09-AAER-2

Battery Charging Specifications and Computing Devices

Recommendations of the
**Information Technology
Industry Council**

Battery Charger Specification Proposal

Test Method Needs to Isolate Off Power

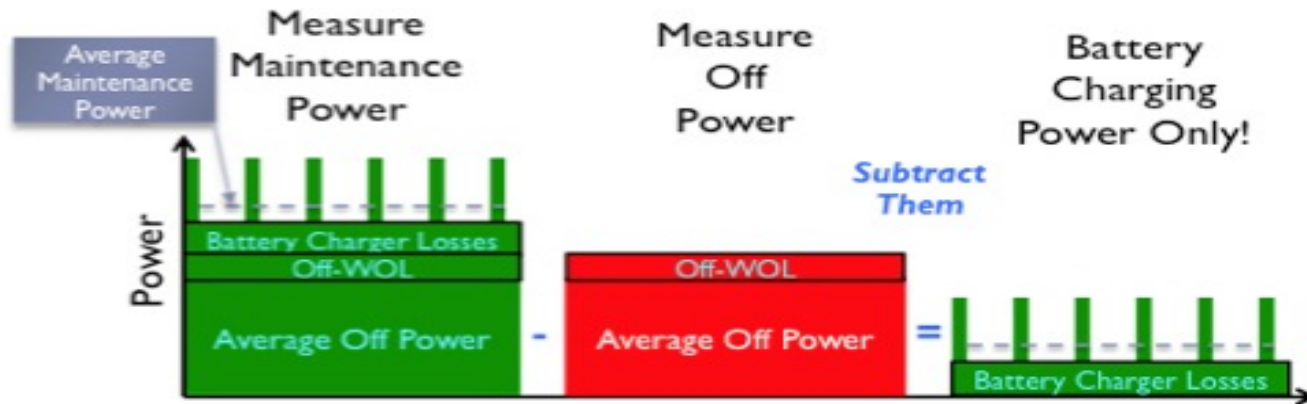
- Current Testing Methodology is not consistent in its measurement of “no battery mode”
 - Spec measures “Off mode” (notebooks) or “EPS No-load mode” (other devices) depending on the device
 - Intent is to distinguish the various power modes needed to measure compliance
 - Green represents Maintenance power over time (dashed line represents the avg. maintenance power)
 - Want to measure this
 - Red representing the average off mode power of the device
 - Want to measure this
 - Grey representing the no-load power of the AC brick
 - Has nothing to do with the efficiency of battery charging system and is already included in the “off power”

Subtracting System Off Power Isolates Battery Charging Power

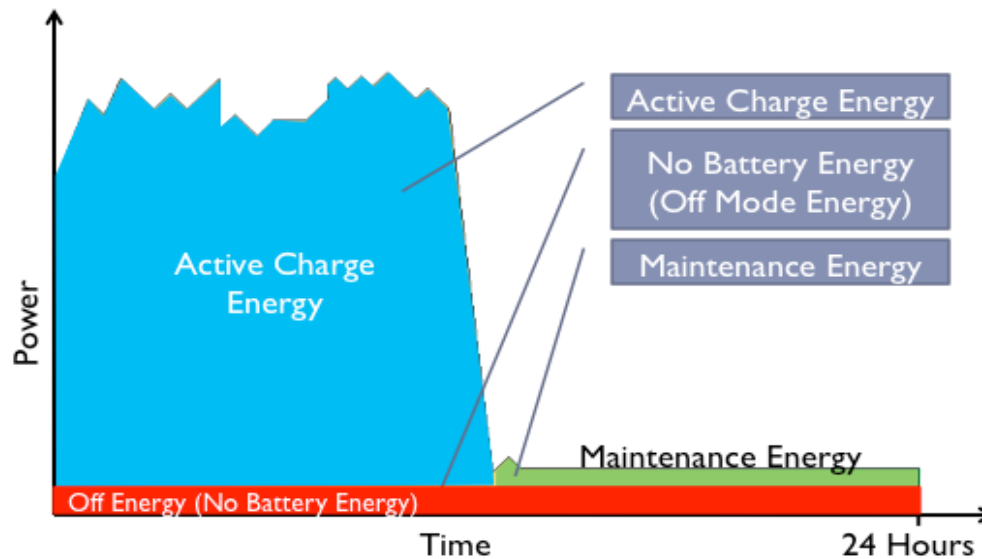
- If you measure the Maintenance Power (green)
 - Includes non-battery related off mode losses due to anything (e.g. Off-WOL, ...)
 - Includes “battery charger losses”
 - Losses due to charging
 - Losses due to maintaining battery
- If you measure the “true” off power
 - Includes non-battery related off mode losses due to anything (e.g. Off-WOL, ...)
 - Does not include “battery charger losses”
- If you subtract the two, then only **the battery related power** is left (**what the CEC/DOE wanted !**)
 - Does not work with “no-load” power (this is not off power)
 - Allows you to totally ignore impact of non-battery charger related off mode losses
 - Versus complicating with “limit adders” or “energy subtract’ers” for special cases (e.g. WoL for computers)

- Calculating 24 hour Battery Charging Energy
 - Measure the 24 hour energy
 - Measure the “off power” (or the “true” no battery mode power)
 - Subtract the “off energy” ($24\text{hr} \times [\text{off power}]$, the red block)
- This value should be less than the established 24 hour battery charging limit
